DRY-REED-TYPE RELAY

302-TYPE

PIECE-PART DATA AND REPLACEMENT PROCEDURES

1.02 This section is reissued to:

Fig. 1—♦302-Type Relay (302B Relay Shown)♦

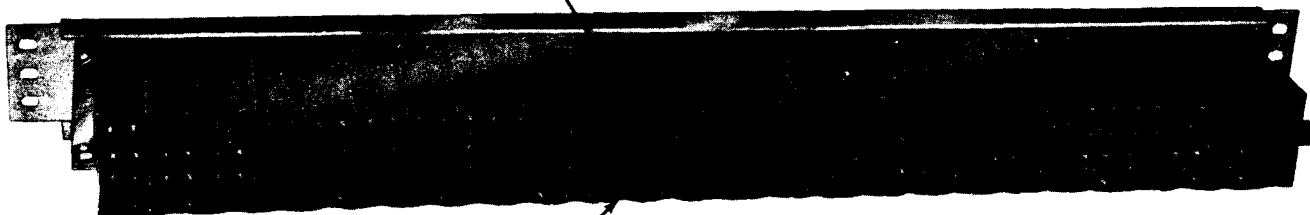
- Advise that the 302A relay has been Manufacture Discontinued.
- Advise that the P-12B803 relay unit has been Manufacture Discontinued.
- Include the 302D relay which replaces the 302A relay and add the 302E relay.
- Cover the use of the P-13B780 relay unit as a direct replacement for the P-12B803 relay unit.
- Revise Fig. 1.

P-13B780 COIL AND SWITCH ASSEMBLY (NONLATCHING RELAY UNIT) (FOR 302D RELAY)

♦(3) When replacing a P-12B803 relay unit with a P-13B780 relay unit, it will be necessary to strap together terminals 5 and 8 on the new unit. Connect wires labeled 1 and 6 to terminals 1 and 4 respectively. Connect wires labeled 2 and 3 to terminals 2 and 6 respectively. Connect wires labeled 4 and 5 to terminals 3 and 7.♦
